R99DK

Blue Bird Body Company has determined that a defect which relates to motor vehicle safety exists in certain 1999 and 2000 year model Blue Bird TC/2000 school and transit front engine buses and Commercial Series front engine buses equipped with optional Hendrickson Parasteer front air suspension. Blue Bird is conducting a recall to correct this defect.

**RECALL R99DK
HENDRICKSON PARASTEER
AXLE DAMPER INSTALLATION INSTRUCTIONS**

Figure 1

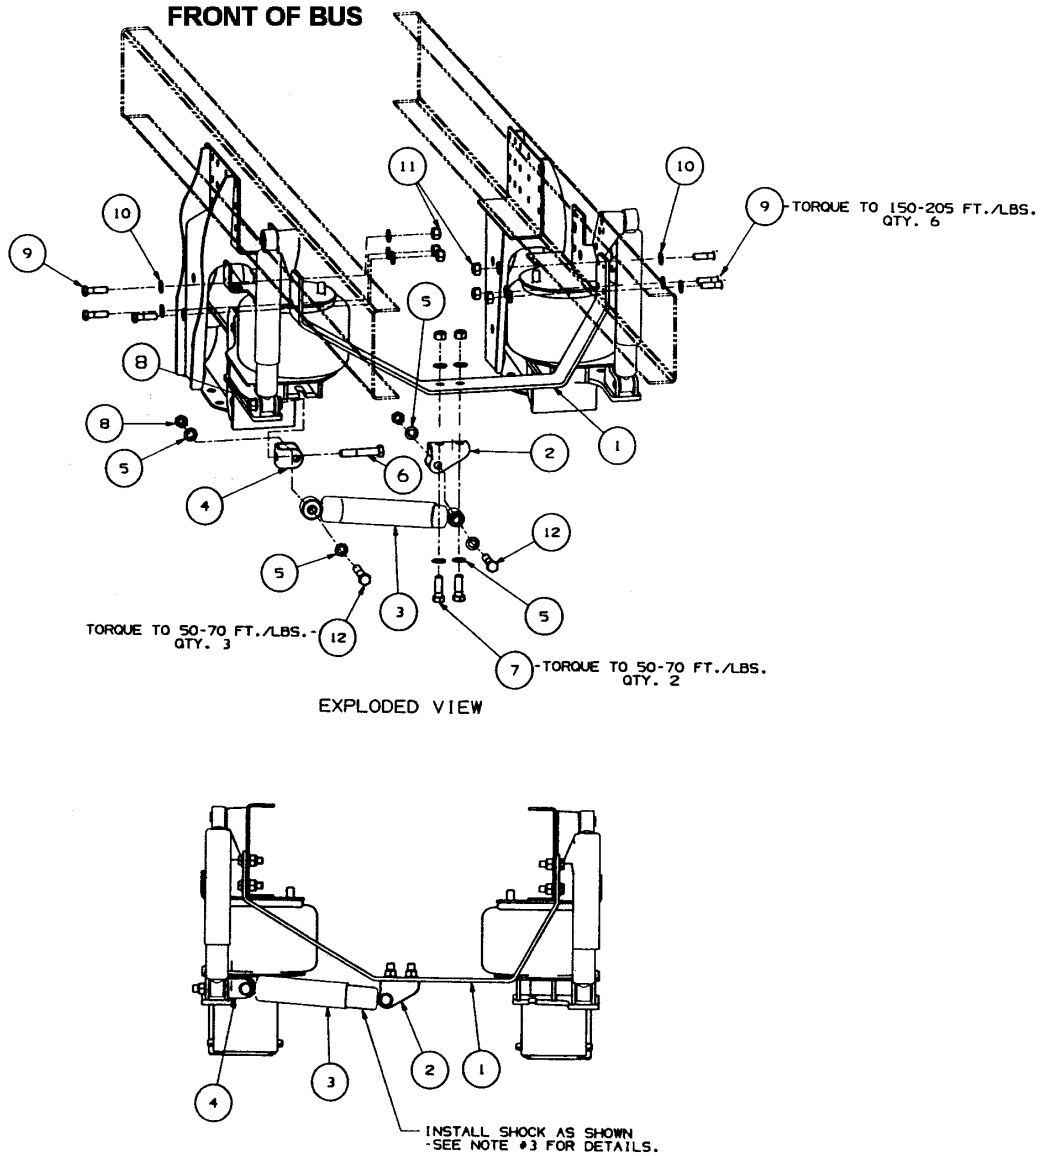
The defect involves the potential occurrence of a shimmy in the front end when the bus hits a bump or pothole. An axle damper must be installed to eliminate the potential for shimmy in the front end.

4. Detach the ABS valves at each side of the frame rails.
5. Position the crossmember (item 1) on the bus behind the front suspension air springs. See Figure 1. Use the upper front hole of the ABS valve at each side of the rail to position the crossmember on the frame rails. See Figure 2.

8. Install the cross member to the frame rails with six (6) 5/8" x 2 1/4 in bolts (item 9), twelve (12) 5/8" hardened washers (item 10) and six (6) 5/8" locknuts (item 11). See Figure 1. Torque fasteners to 150-205 ft. lbs.

12. Assemble the stabilizer shock absorber (item 3) to the two brackets (items 2 and 4) using 3/4" x 3 3/4" hex bolt (item 12) 3/4" hardened washer (item 5) and 3/4" locknut (item 8). See note 3 on page 2 for shock installation. Torque fasteners to 50-70 ft. lbs.

1. Replace all used locknuts with new locknuts provided in kit.
2. Follow the recommended torque for fastening the hardware provided in the service kit.
3. Position stabilizer shock (item 3) with large end toward outside of bus as shown in illustration at bottom of Figure 1.
